SOLICITATION AMENDMENT

Title - Sujet Submersible Mixers	
Solicitation No. - N° de l'invitation F4758-190016/A	Amendment No. - N° modif. 001
Client Reference No. - N° de référence du client F4758-190016	Date 2019-09-03
GETS Reference No. - N° de référence de SEAG PW-\$MCT-041-5601	
File No. - N° de dossier MCT-9-42029 (041)	CCC No./N° CCC - FMS No./N° VME
Solicitation Closes - L'invitation prend fin at - à 02:00 PM on - le 2019-09-10	Time Zone Fuseau horaire Atlantic Daylight Saving Time ADT
F.O.B. - F.A.B. Plant-Usine: <input type="checkbox"/> Destination: <input checked="" type="checkbox"/> Other-Autre: <input type="checkbox"/>	
Address Enquiries to: - Adresser toutes questions à: Owens (MCT), Shannon	Buyer Id - Id de l'acheteur mct041
Telephone No. - N° de téléphone (506) 962-5402 ()	FAX No. - N° de FAX (506) 851-6759
Destination - of Goods, Services, and Construction: Destination - des biens, services et construction:

Solicitation Amendment No. 001

Title Submersible Mixers

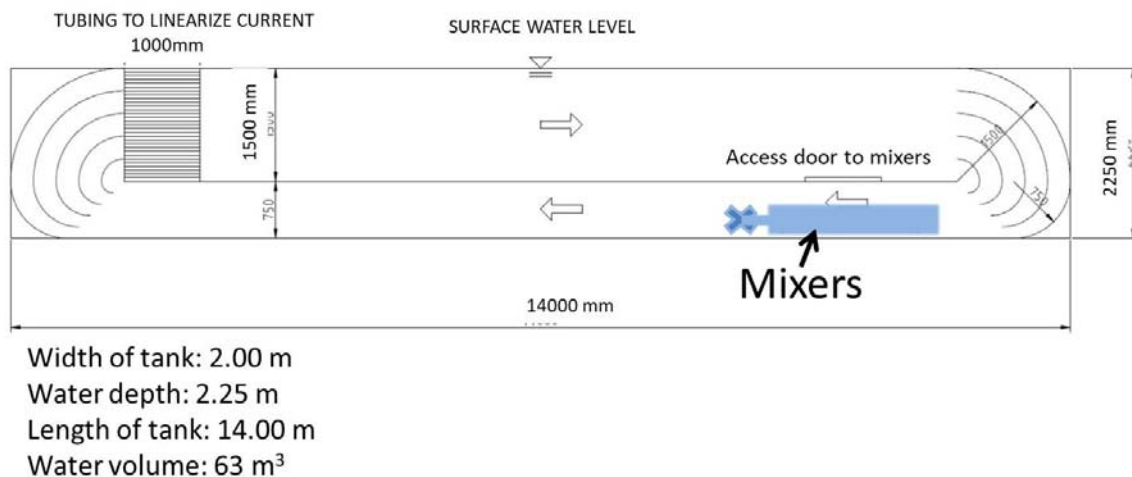
Q1: Could you please confirm the size of the tank (that the mixers will be installed in)?

Q2: Is a clearer drawing of the tank available? The drawing provided in Annex A of the RPF is not readable

A1: The revised drawing now indicates that the tank size is 2.00 m (width) x 2.25 m (depth) x 14.00 m (length). The tank holds 63 m³ of water.

A2: A higher resolution drawing is provided below.
